APPEAL SUMMARY

Appeal ID: 23538	Project Address: 3330 SE 69th Ave
Hearing Date: 3/11/20	Appellant Name: Tim Ayersman
Case No.: B-005	Appellant Phone: 971-200-7213
Appeal Type: Building	Plans Examiner/Inspector: John Cooley
Project Type: commercial	Stories: 3 Occupancy: E, B, A-2, A-3 Construction Type: II-B
Building/Business Name: Portland Public Schools - Kellogg Middle School	Fire Sprinklers: Yes - Fully-sprinklered throughout
Appeal Involves: Reconsideration of appeal	LUR or Permit Application No.: 19-130649-CO
Plan Submitted Option: pdf [File 1] [File 2]	Proposed use: Middle School (Grades 6-8)

Appeal item 1

Code Section	§703.2 Fire-resistance ratings
Requires	§ 703.2 Fire-resistance ratings. Where materials, systems or devices that have not been tested as part of a fire-resistance-rated assembly are incorporated into the building element, component or assembly, sufficient data shall be made available to the building official to show that the required fire-resistance rating is not reduced
Code Modification or Alternate Requested	This appeal was requested by BDS Plans Examiner, John Cooley. The intent of the appeal is to confirm the fire-resistance-rated assembly of a fire wa

1/G-202

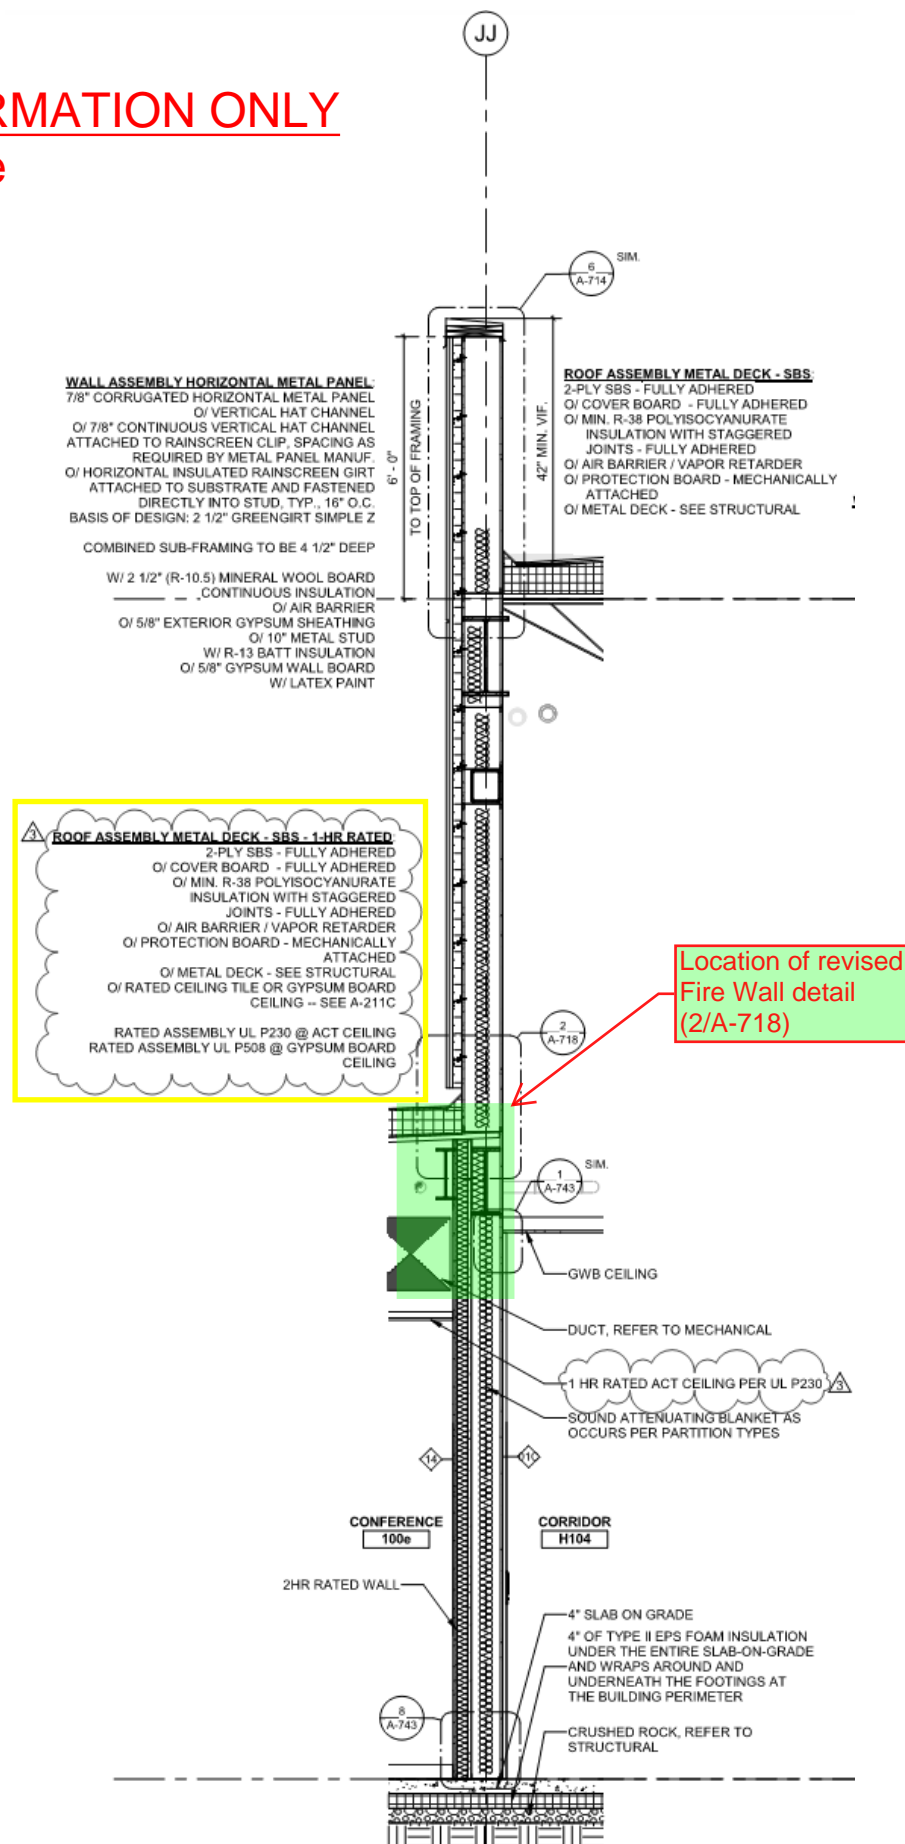
- Location of Fire Wall and appeal proposal.
- 1-hour rated roof assembly and supporting element extents.

4/A-419

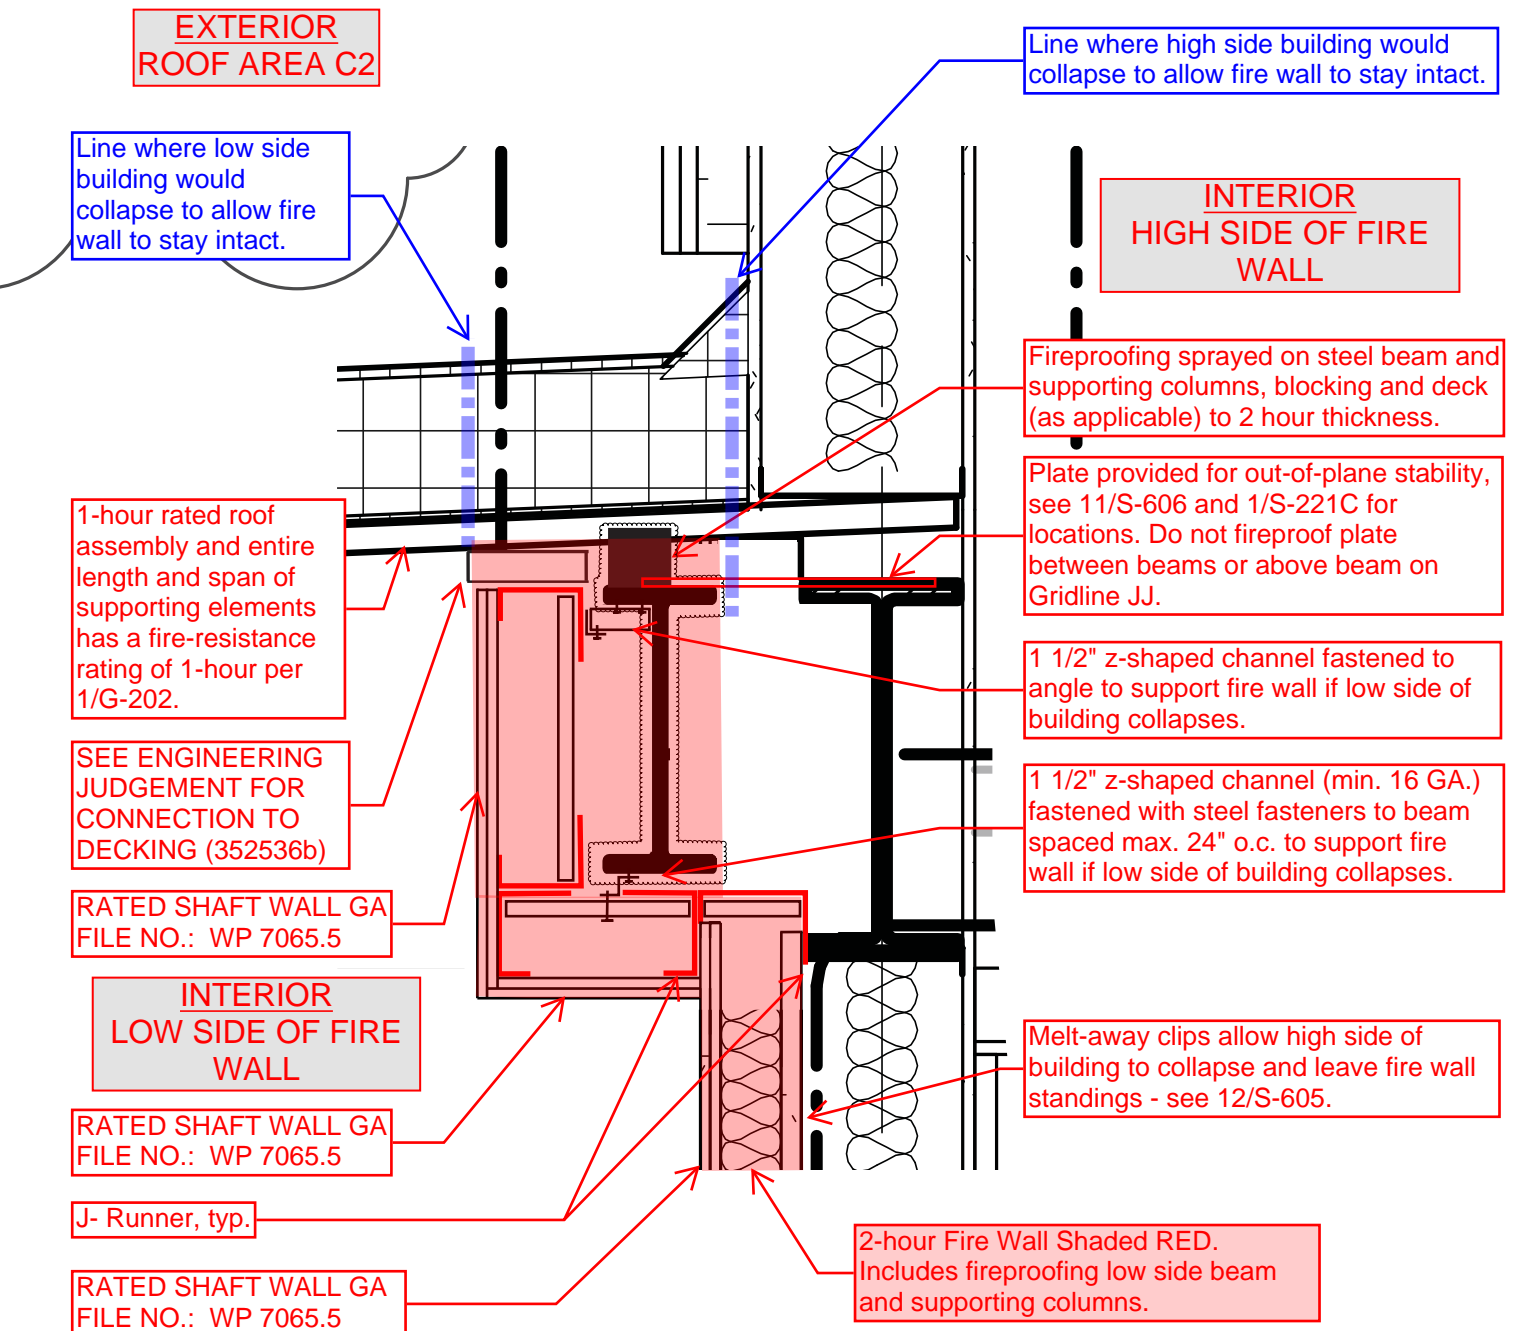
- Wall section at Fire Wall along Gridline JJ.
- Location of revised Fire Wall detail.
- Description of 1-hour rated roof assembly

Proposed Fire Wall Revision Concept Not to Scale

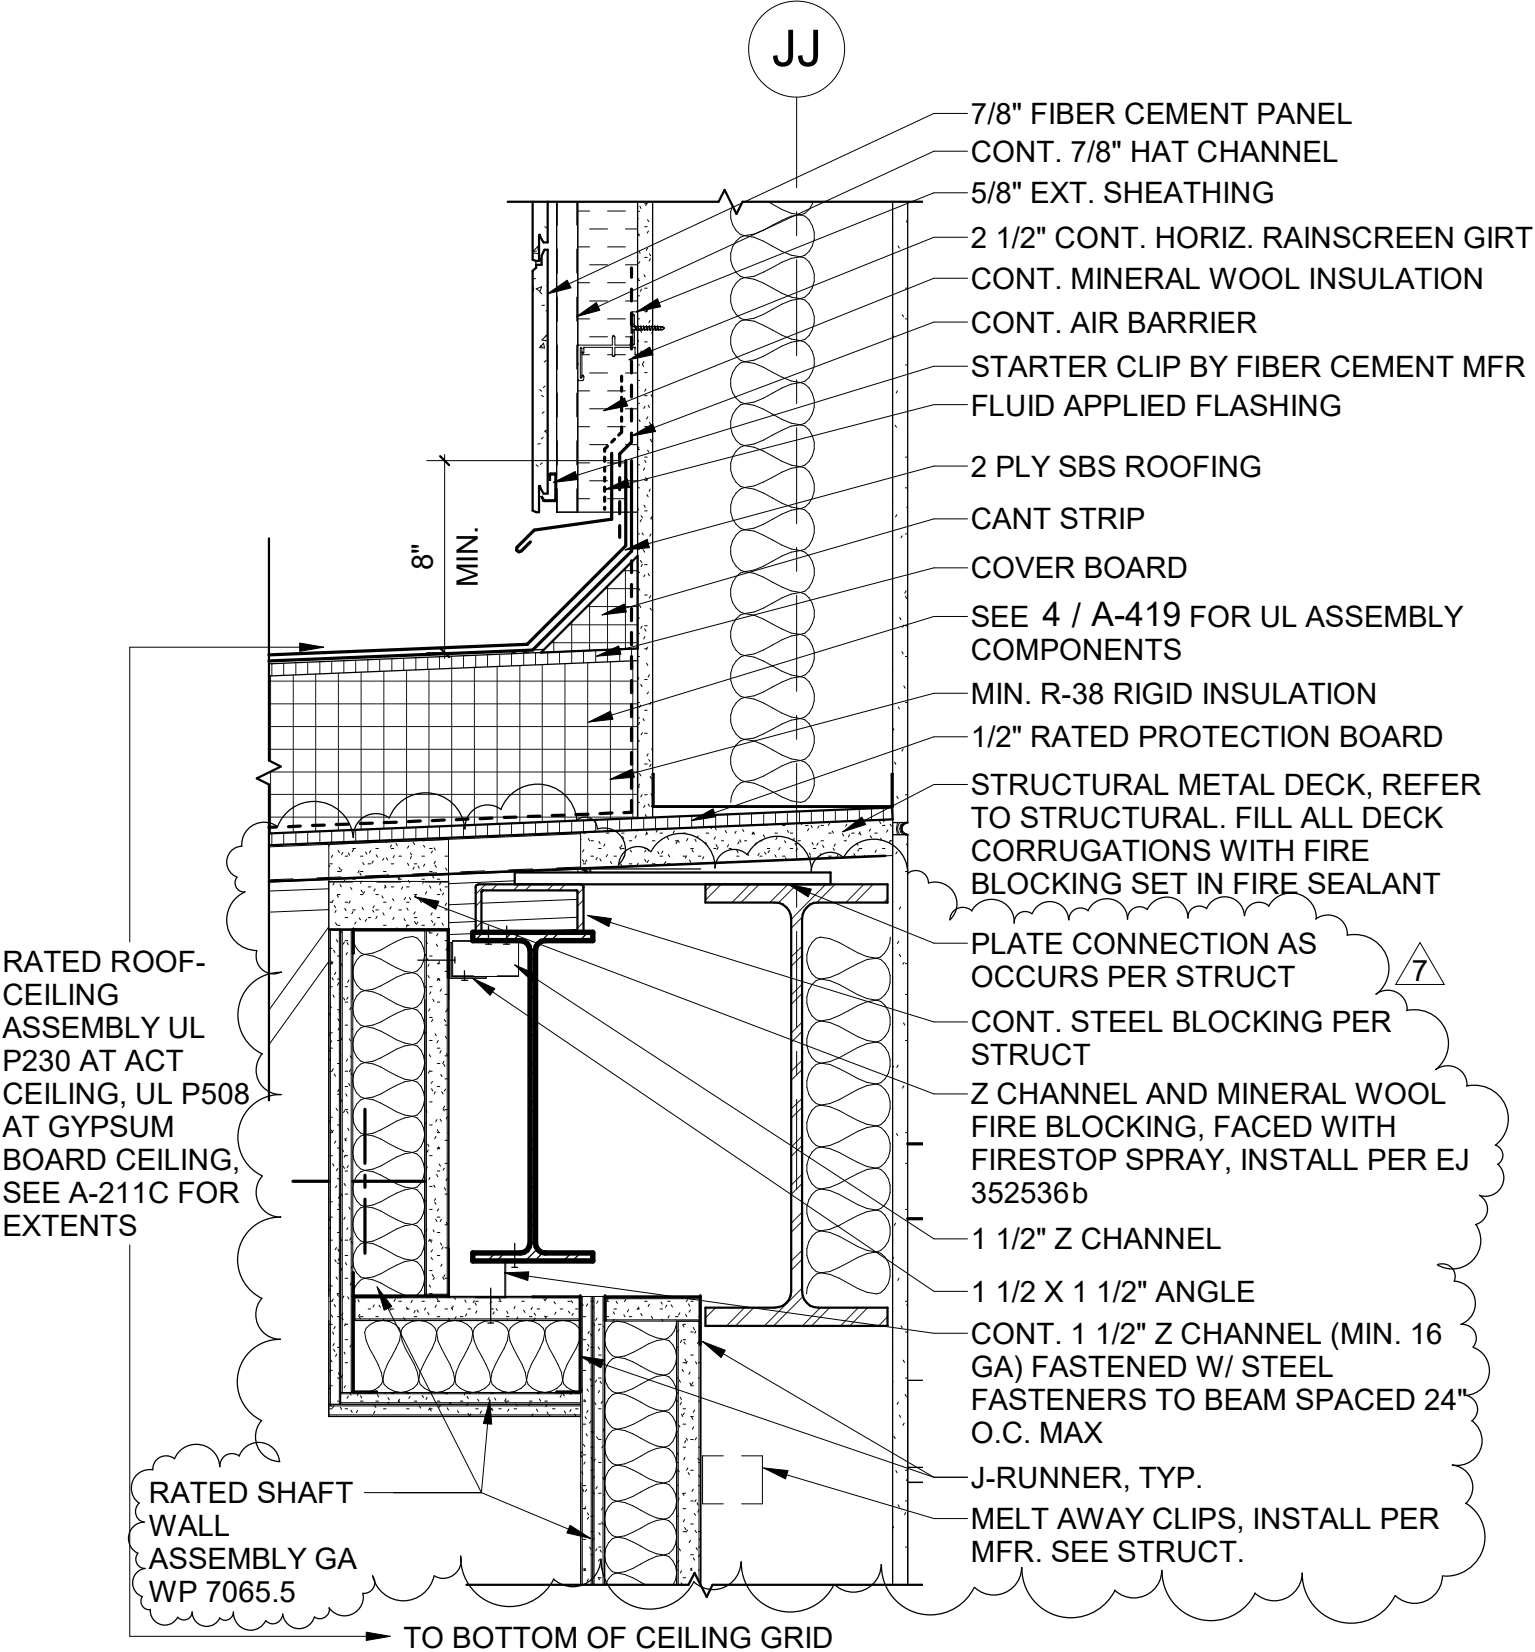
See 4/A-419 and 2/A-718 for:
- Exterior Wall and Roof Construction
- UL for Rated Roof - Ceiling Assembly
- GA Rated Shaft Wall Assembly

▪ Fire Wall revision overview sketch.

2/A-718

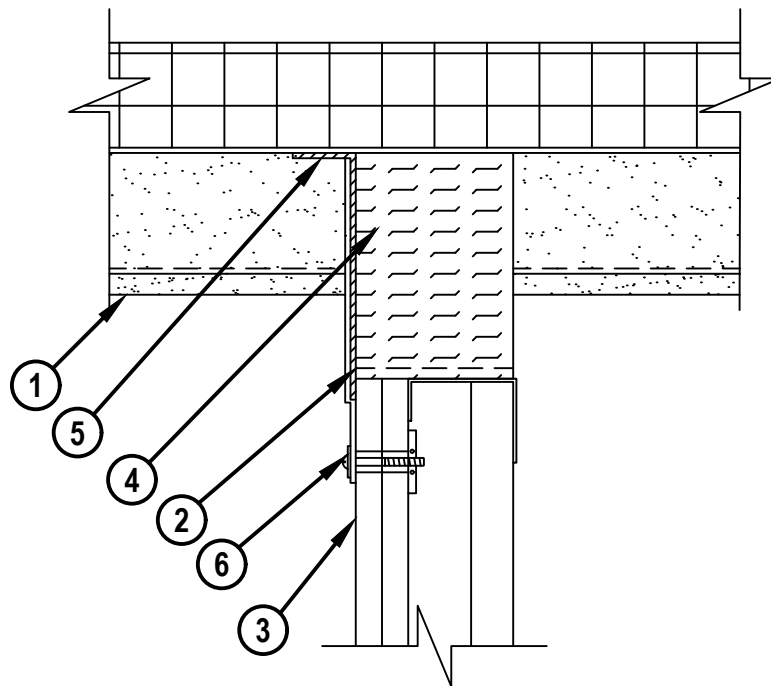
■ Proposed revised detail at Fire Wall

WP 7065.5

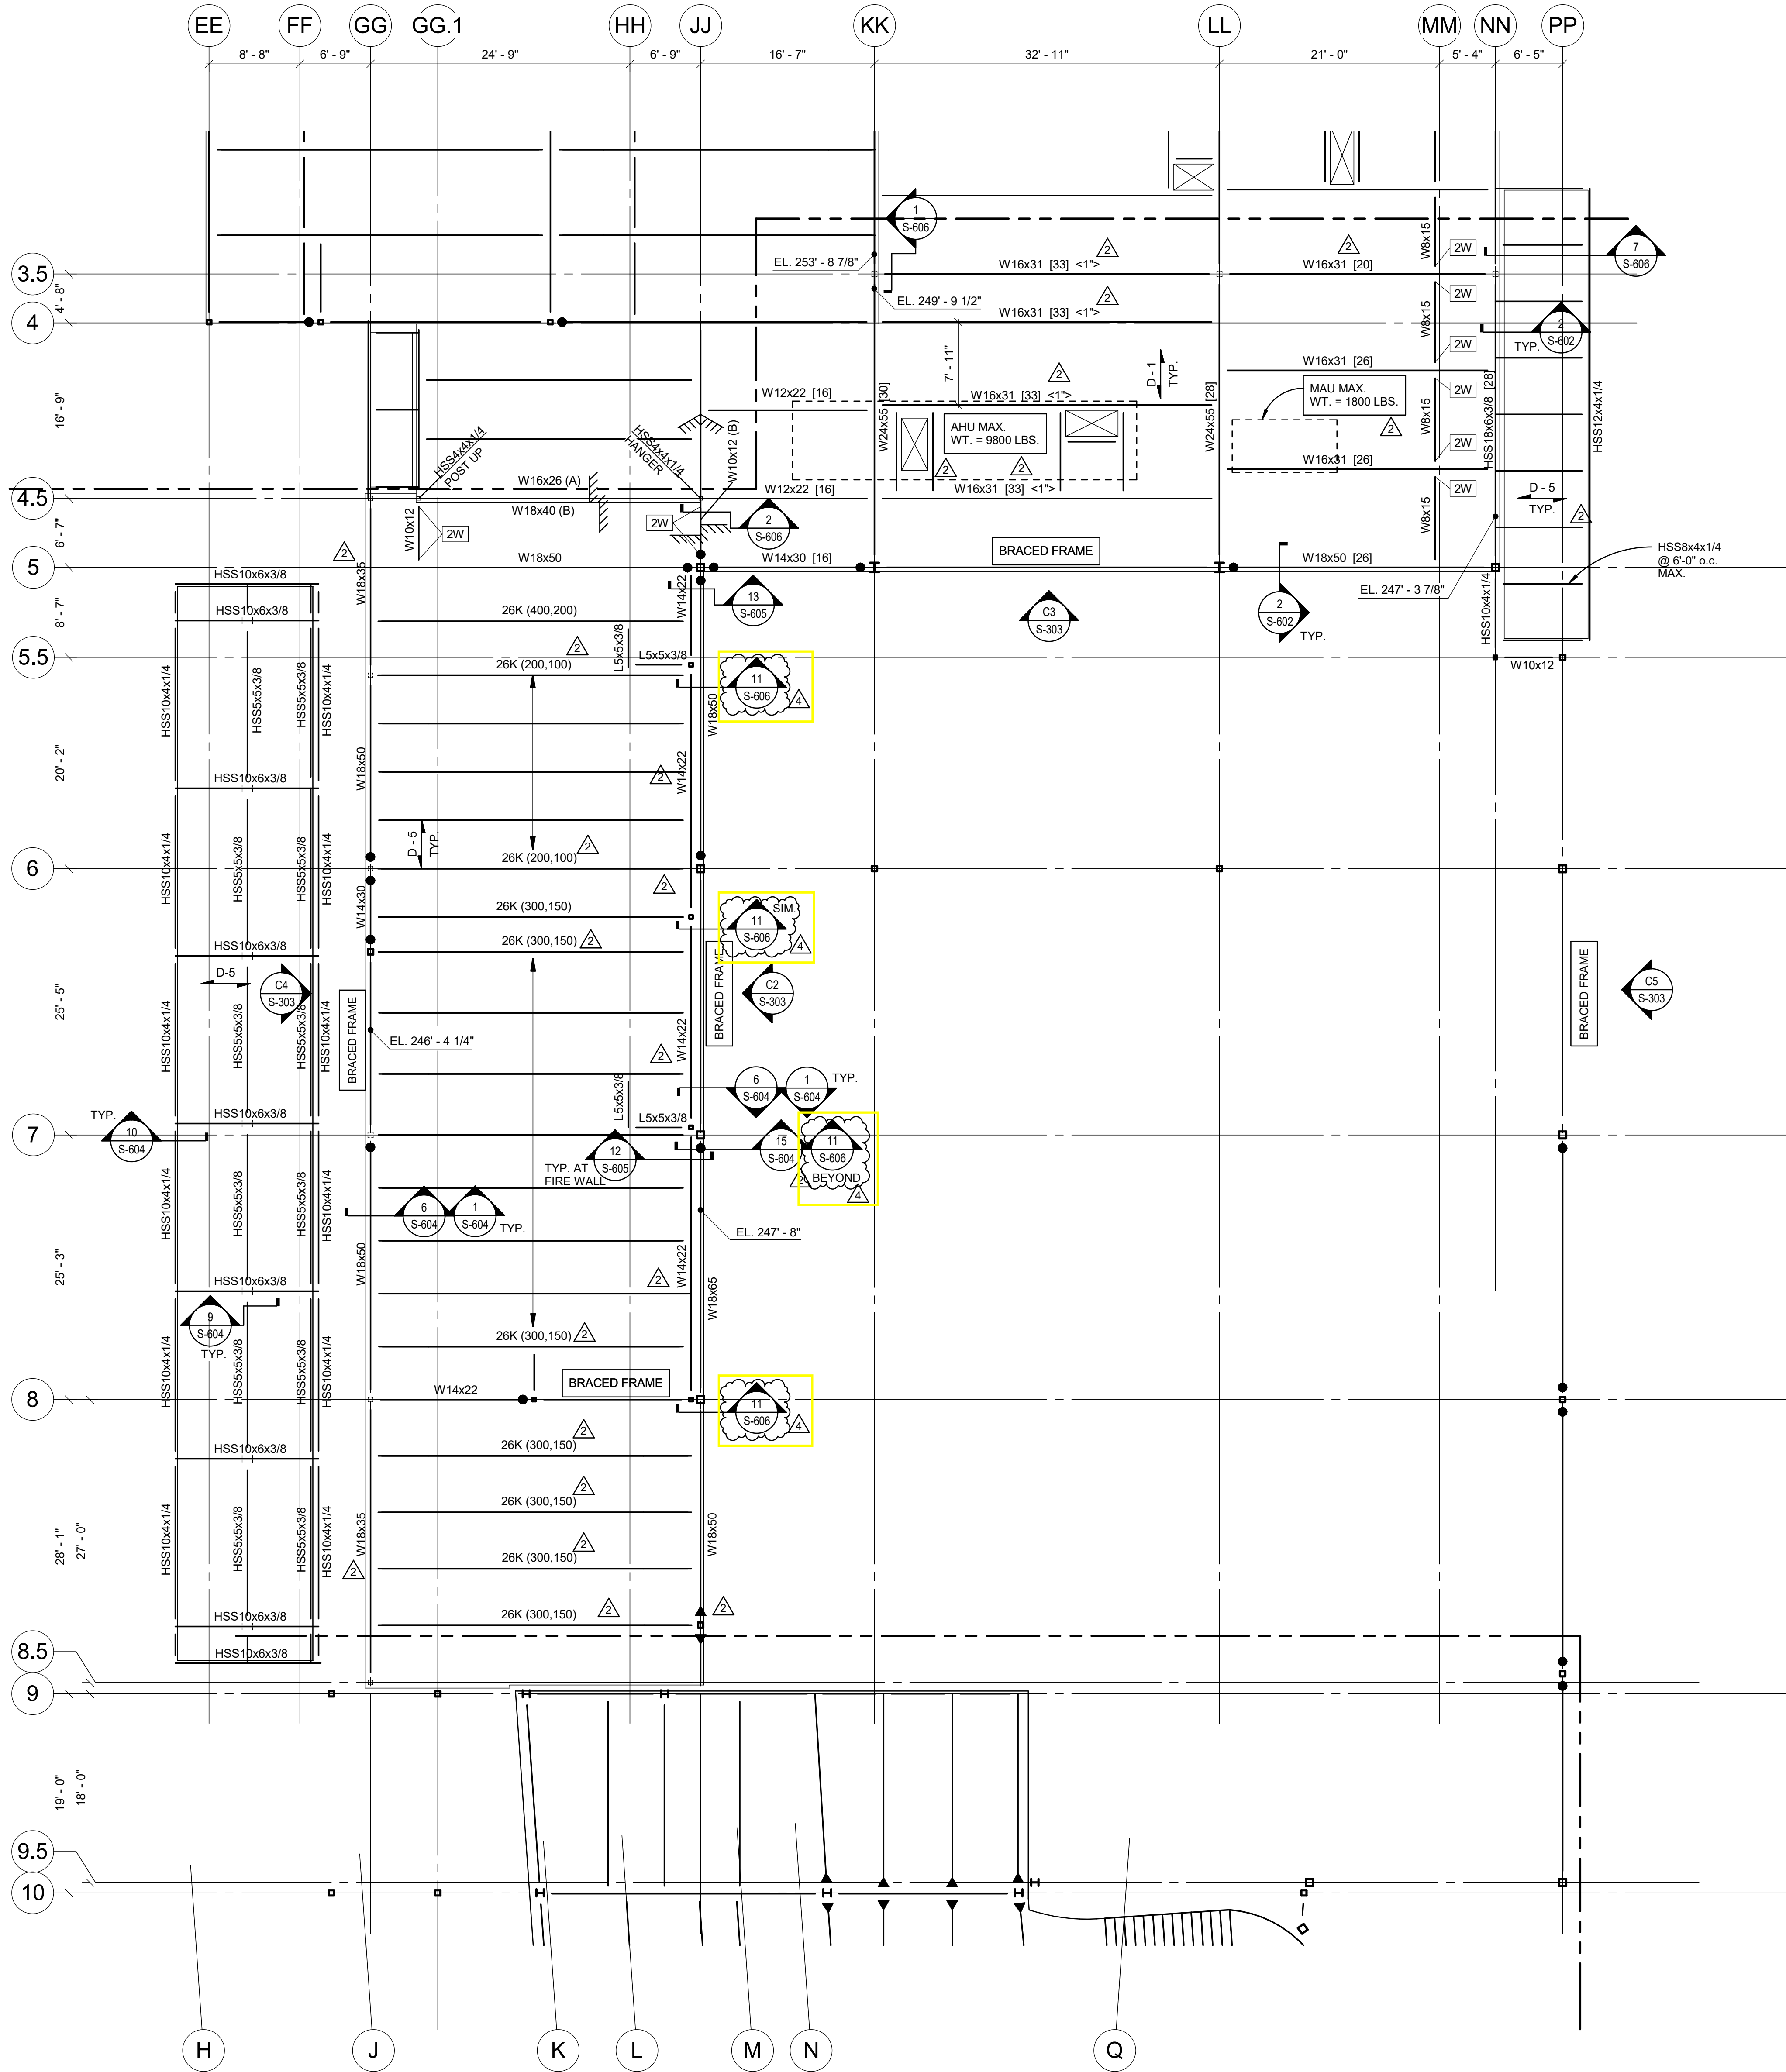
■ Listing for GA WP 7065.5.
